AGENDA MEMORANDUM

Planning Commission Meeting of August 10, 2022

Driscoll Village Lots 27-37 Block 7

Request for a Plat Waiver of the Sidewalk Construction Requirements in Section 8.1.4 and 8.2.2 of the Unified Development Code

Exhibit A

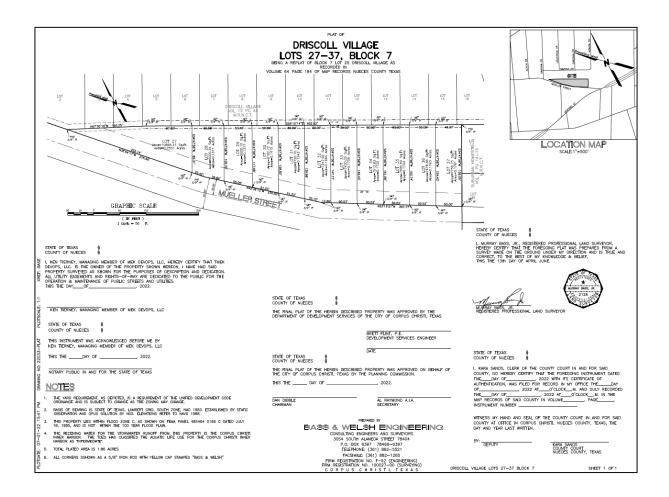
- 1. Building the sidewalk on Mueller Street will connect with the sidewalk network at Nandina and link the neighborhood on the north. The new sidewalk will also connect with the tied sidewalk at Mueller.
- 2. The opposite side of Mueller Street has a sidewalk with curb and gutter.
- 3. The neighborhood patterns show a combination of tied sidewalks, sidewalks with buffers and sidewalks on the property side of the ditch.
- 4. Woodlawn Park and a senior center are located approximately 300 feet from the property.

Staff recommends **disapproval** of the waiver from the sidewalk construction requirement on Mueller Street
